Technical Document LA24046

Part 2 – Technical Requirements

NRCB USE ONLY	Application number	Legal land description
Approval Registration X Authorization	LA24046	NW 6-17-21 W4M

Re: Geotechnical Review and Evaluation NRCB Permitting of Proposed Solid Manure Storage NW-06-017-21-W4M, near Vulcan, Alberta

Figure 1: Site Layout & Borehole Locations

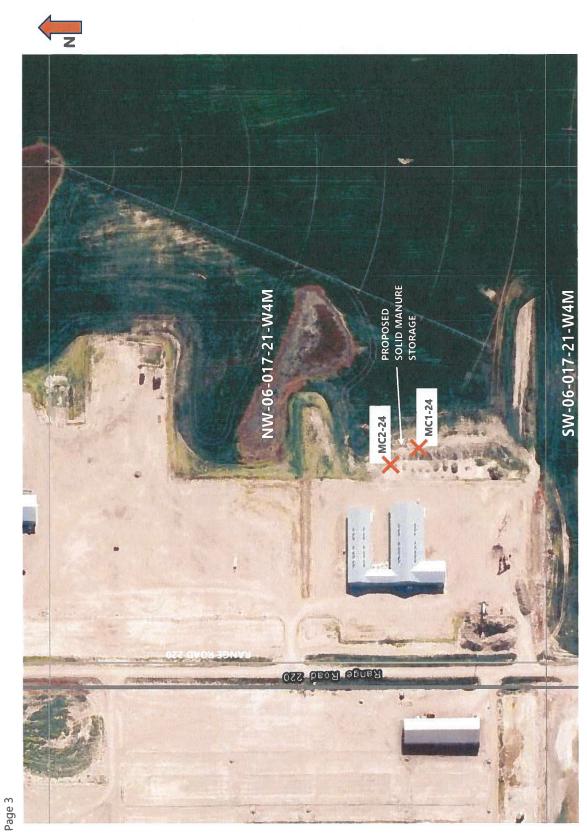
In order to demonstrate the suitability of the naturally existing soils for consideration as a naturally occurring protective layer to the groundwater resource, two boreholes were advanced at the site on November 8, 2024. The boreholes were advanced at the approximate locations denoted as MC1-24 and MC2-24 on Figure 1, attached.
